## **Stage 1 Road Safety Audit**

**Lissinagroagh Wind Farm, Manorhamilton, Co. Leitrim**

**On behalf of Future Energy Ireland**

#### 4.1.4 Development Junctions – Width

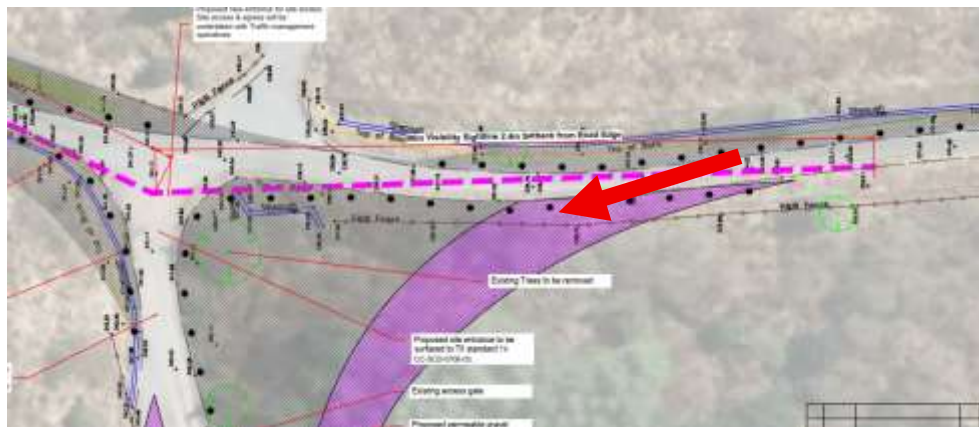
**Problem:** There are a number of existing junctions that are called up on the drawings as “proposed”, however existing tracks / roads exist in the majority of these areas. The existing tracks are quite narrow. It is not clear from the drawings if these tracks are to be replaced with new and wider roads, or if the vehicles are to use the existing.

**Hazard:** Vehicles may be too wide for the existing tracks and run on the verge. Overturning of construction vehicles may result.

**Recommendation:** The Design Team should ensure the drawings indicate the existing road width and also ensure road widening is provided where the swept path requires.

4.1.4	Yes	No	Existing road widths have been shown on the drawings. As outlined in the traffic Management Plan traffic will be managed during construction stage along the public road network. Adequate road width will be provided to accommodate the vehicle swept paths, without the need for the vehicle to reverse / realign.	Yes

### 4.2.2 Site Access 4 - Drainage

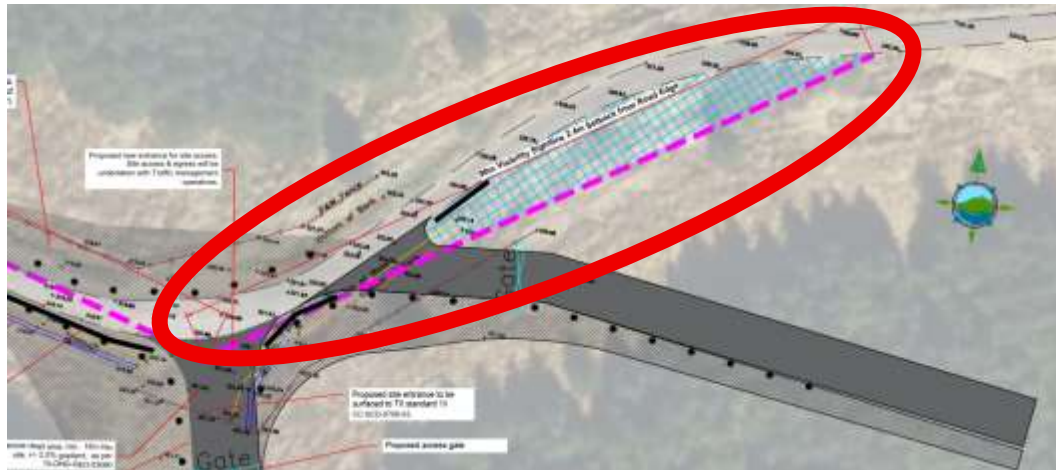
**Problem:** The new access road crosses an existing roadside open drain. The access road may sever the drain such that flooding of the public road results.

**Hazard:** Aquaplaning type collisions may result.

**Recommendation:** The Design Team should provide a suitably sized culvert under the new road and connect the existing open drain to this culvert.

4.1.5	Yes	Yes		
4.1.6	Yes	Yes		
4.2.1	Yes	Yes		
4.2.2	Yes	Yes		
4.2.3	Yes	Yes		
4.2.4	Yes	Yes		
4.2.5	Yes	Yes

### 4.2.3 Site Access 5 & 6 – Junction Visibility

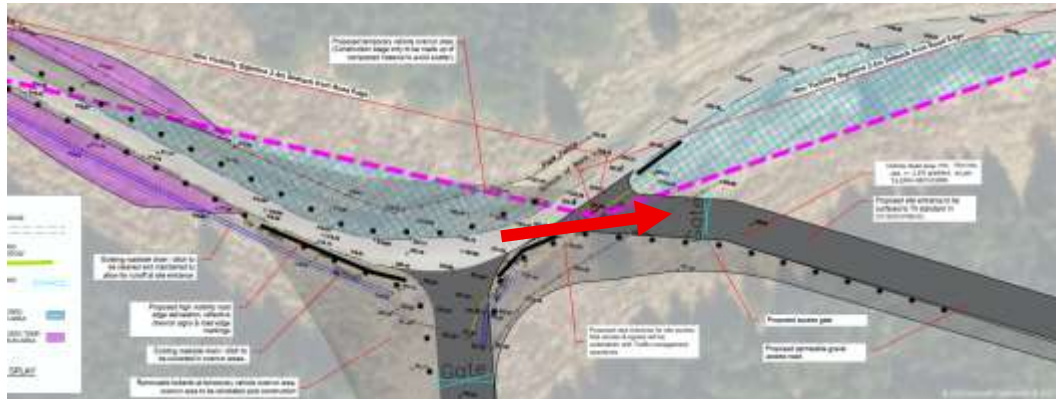
**Problem:** The lands rise in level to the east of the junction. Although the junction visibility splay is shown on the drawings, there is concern these splay crosses over the brow of the hill to the east. Motorists' visibility to the right when exiting may be restricted due to this hill.

**Hazard:** Development traffic may exit the junction into the path of oncoming traffic.

**Recommendation:** The Design Team should ensure vertical visibility is achieved at this location.

#### 4.2.4 Site Access 6 – Junction Angle

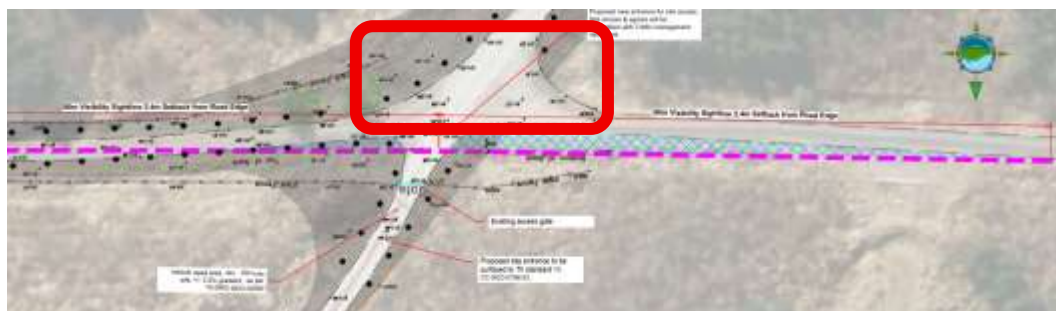
**Problem:** The new access at Entrance 6 is to an acute angle with the existing public road. There is concern eastbound public road users will errantly drive into this access rather than continue around the bend on the existing public road.

**Hazard:** Public road traffic may impact with the closed gate, especially during the hours of darkness.

**Recommendation:** The Design Team should realign the junction to be more perpendicular with the existing public road.
